HOWARD COUNTY HISTORIC PRESERVATION COMMISSION

## **2020 Minutes**

## **July Minutes**

**Thursday, July 9, 2020; 7:00 p.m.**

Figure 1 - Proposed projecting sign

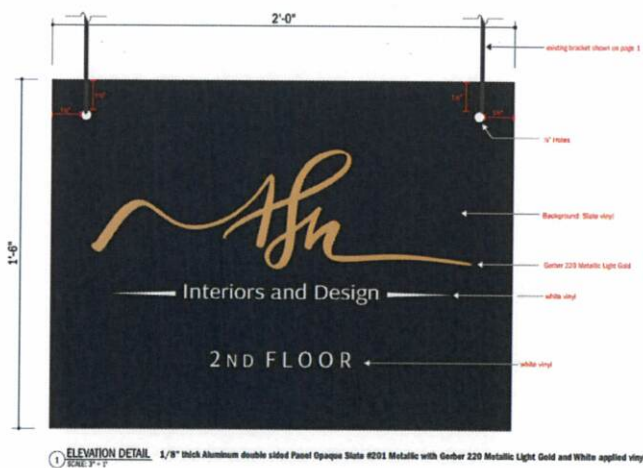
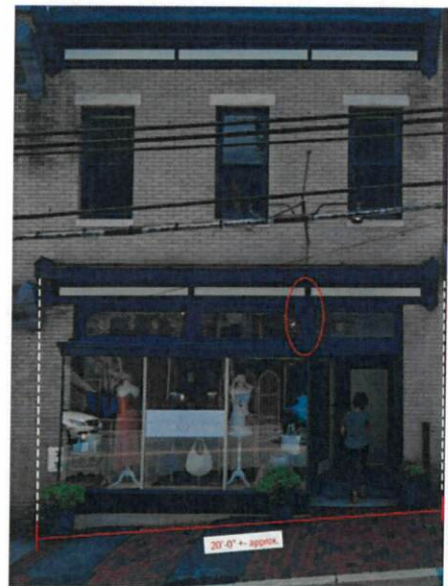
**Staff Recommendation to the HPC:** Staff recommends the HPC approve sign #1 as submitted. Staff recommends the HPC provide advice on the design of Sign #2, the door sign; or approve if the HPC finds the sign complies with the Guideline recommendations.

Mr. Reich said he did not have a problem with either of the signs as they both comply with the Guidelines; they are the right size and include the correct number of colors. Mr. Reich said he is not worried about the sign on the door as it is set back and recessed. The door sign does not look out of place to him. Mr. Reich said it would be nice if the sign could fit within one of the cross members on the panels but finds both signs to be nice as they coordinate. Mr. Reich said he was okay with the proposal.

Figure 7 – Proposed partial side elevation looking west

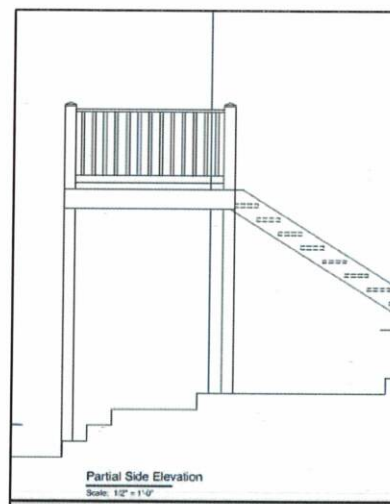
Mr. Reich said he was confused by the details and asked if the Commission should be using the May application request in conjunction to the July request to understand the full scope of the request and details of materials and schematics. Ms. Burgess clarified that the Commission is looking for the same details that are present with both applications. Mr. Alghatrif explained that the porch would remain the same detail wise, the proposal would include mahogany flooring, fir railing, color to match that was provided to the Commission. The gutter would match existing and the trim pieces were previously proposed as jigsaw but have been removed.

Mr. Reich showed a picture of the existing conditions of the porch from the staff report and confirmed that each element was remaining the same. Mr. Alghatrif said the only exception would be a wider baseboard scenario and stated the types of wood that would be used, such as Douglas Fir, Pine and tongue and groove Mahogany flooring finished with teak oil. Mr. Reich asked if everything will match the same size of the fascia, same size of trim on the edge of the decking, design of the rail. Mr. Alghatrif said that was correct, but he will be using a 6-inch wide baseboard, which is reflected in the plans, and

instead of a 2x4, it would be a 2x6 and said that is all that is changing in the railing design. Mr. Reich said there was a 6x6 post and asked if that continued to the railing, or if the railing post becomes a 4x4. Mr. Alghatrif said it would become a 4x4. Mr. Reich said that Mr. Alghatrif would be matching all of the railing details, and all of the details around the edge of the deck, except for the 1x6 instead a 4x4 post and change the posts to 6x6 posts and extend the entire porch 2 feet out. Mr. Reich asked what material the soffit would be and said he saw light fixtures. Mr. Alghatrif said the soffit will match the wood beadboard and the porch will have recessed lights that would be generic, 3-inch, matching what they have now and painted to match the color submitted. Mr. Reich asked for clarification on where the additional submission materials containing this info were found. Mr. Alghatrif said the material was put in a table in the submission. Mr. Reich asked if he was supposed to combine this was the previous months paperwork. Ms. Burgess said that the May and July materials needed to be combined.

Ms. Zoren said she agreed with Mr. Reich as far as the materials and wanted Mr. Reich's opinion on the column spacing as the Applicant has changed the spacing. The proposal shows paired columns with a single column on the end. Ms. Zoren said that all other porches on Main Street have very regular column spacing and the way the application had the columns paired, they were not close enough to be considered a pair. Mr. Alghatrif said he spaced the columns as they were in order to highlight the windows on the façade of the building façade and not block them, but could change the columns.

Ms. Tennor said she agrees with the Applicant, it makes sense to have the columns arranged for the window spacing. When she reviewed the application originally, there was concern that the increase of the depth of the porch by two feet would change the streetscape. Ms. Tennor said she no longer has the concerns with the expansion and said the historical photo submitted with the application strengthens the Applicant's case for his request. Ms. Tennor said she liked how the way the stair was handled and that the design has come a long way. Ms. Tennor said she appreciated the inclusion of information that was submitted with the new application.

Figure 21 – Proposed rear (South) elevation, Sheet A6.

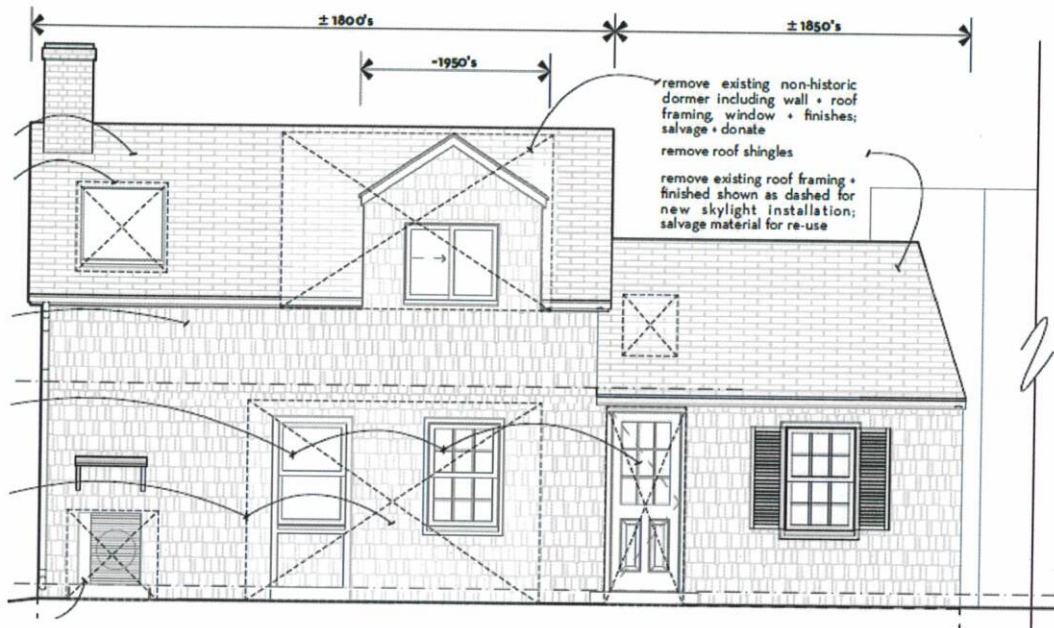
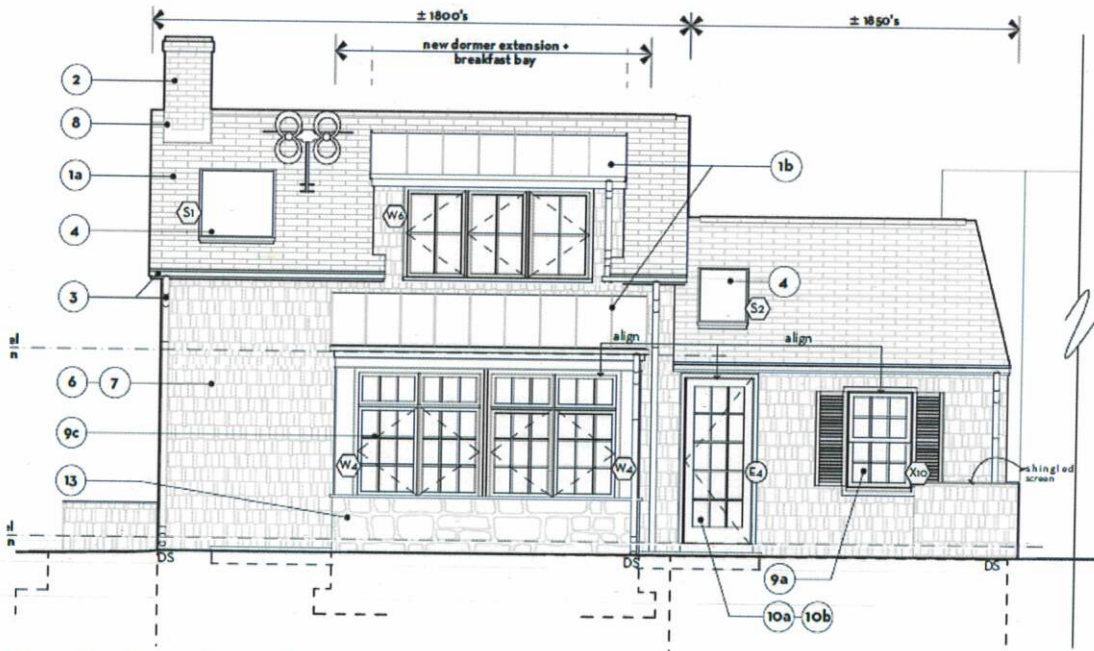
The proposed alterations and repairs to the roof, gutter, rear dormers and skylights comply with the Guideline recommendations. The roof on the historic house is currently asphalt, and it will be replaced in-kind with new asphalt. Historically, the HABS photo in Figure 15, shows the roof was wood shingle, which is not as practical to use today. The new shed awning/overhang over the front door, bay addition and new dormer will have a standing seam metal roof, which is a historic building material. The new dormer complies with the Guideline recommendations and will preserve the balance and massing of the building and will match the proportions of the existing building. The existing dormer does not preserve the massing of the structure. The new shed dormer will also balance the shape of the new bay addition. The replacement asphalt shingle roof is eligible for tax credit per Section 20.112 and 20.113 of the County Code. The new metal roofs, while historically appropriate, are for modern additions and are not eligible for tax credits.

Figure 15 - Comparison of proposed veneer against existing brick.

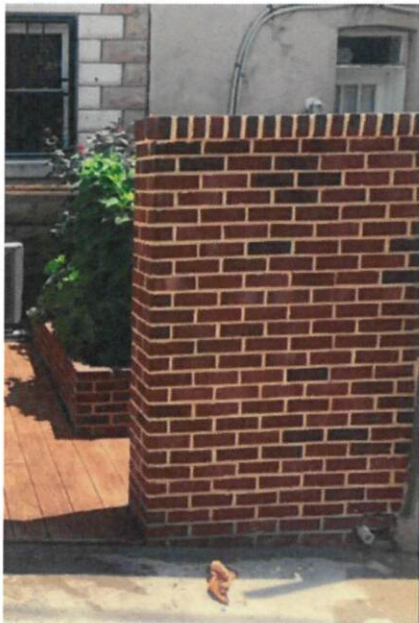
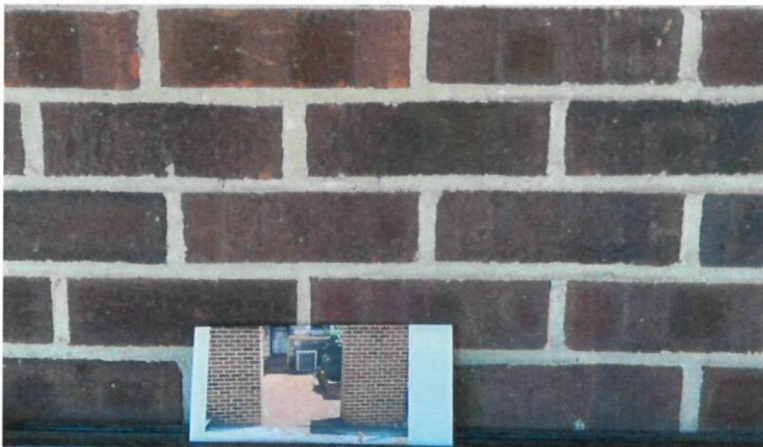
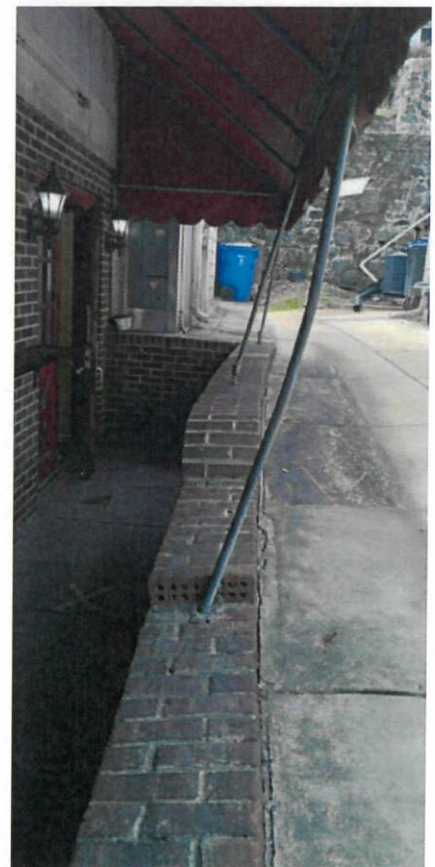
Mr. Roth said he was fine with the material submitted as the wall faces the building and would not otherwise be visible. He said the process of rebuilding the wall, moving it and using the veneer was fine. Mr. Roth said the Commission was also supposed to approve the styles of the tables and chairs shown in Figure 12 of the agenda. Mr. Roth pointed out the third option on the right and said the chairs look like white plastic chairs that are stackable and found the style was not appropriate.

Figure 20 - Site Plan showing proposed planting. Larger, clear version found in application packet.

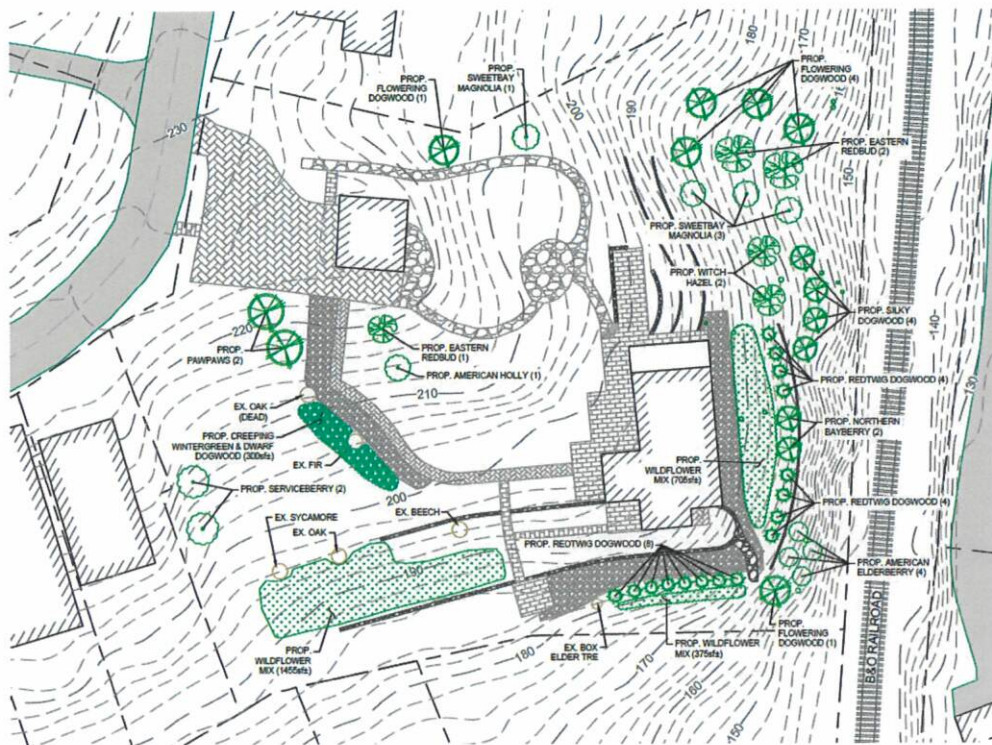
Mr. Roth and Mr. Taylor discussed the Commission's role with reviewing replacement trees in a historic setting. Mr. Roth said the proposed plantings seem to be appropriate within the Guidelines as they are native trees and would complement the historic setting and based on locations of where the previous trees where as shown on sheet C-1 of the application tree removal schedule labeled T1-T12, the trees were very close to the house or on a steep slope in close proximity to the railroad tracks it may have been appropriate to remove them.

**Figure 9 – Northwest Elevation - Historic American Buildings Survey Detail from 'A Sketch from Rock Hill' Lithograph of Thomas Campbell, Baltimore, Drawn by R. C. Long, c. 1835 Howard County, MD**

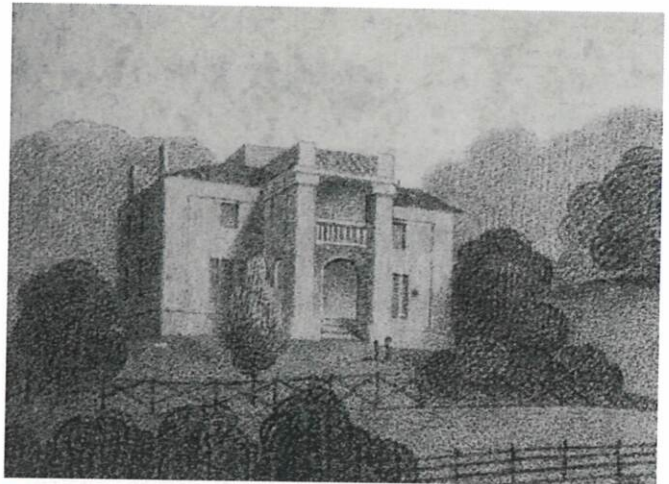
Mr. Reich noted there was no clear historic record of what existed and he could not determine what was most historically appropriate. He said the current rear elevation looks odd with the entry into the basement and referenced Figure 5 of the staff report "Northwest elevation facing Mt. Ida and Courthouse parking lots" stating the basement would typically have had a side entry stair and the main rear elevation entrance would have had stairs leading straight up to the first floor. Mr. Reich noted a preference for this solution acknowledging it was an expensive remedy. Ms. Kepnes suggested painting the first-floor railings white to bring more attention to that entry and paint the basement doors darker to better blend them.

Ms. Zoren noted the column lengths visible in Figure 5 and said that having the porch deck extend out perpendicular forward from the doors would create a horizontal deck line that would visually shorten the columns by about 3 feet. She explained this would give the appearance of a weird intersection with the vertical columns. Ms. Zoren agreed with Mr. Reich's suggestion to build a front set of steps with a side access stair going down to the basement. Ms. Zoren said the Commission would need to see elevations and a section showing the access to the basement when the Applicant comes back for a Certificate of Approval. The Commission will need to understand the two side stairs proposal to the first floor and how that will work with the service stairs if that solution is kept as the plan.

Mr. Reich said the columns were probably shorter originally, given the other elevations on the building. Mr. Reich said the columns would look better if the stone base continued out to the porch level, similar to the base on the elevation overlooking Church Road. Mr. Reich suggested building the porch to come out even with the column on the outside rather than inside. Ms. Zoren referred to the lithograph in Figure 9 and noted the stairs could have started at the columns. Mr. Roth asked how realistic the lithograph really was. Ms. Zoren said it might not be realistic, but it shows the columns hitting the same place they do right now with relationship to the front first floor door. Mr. Roth said the picture does not show the basement door at all.
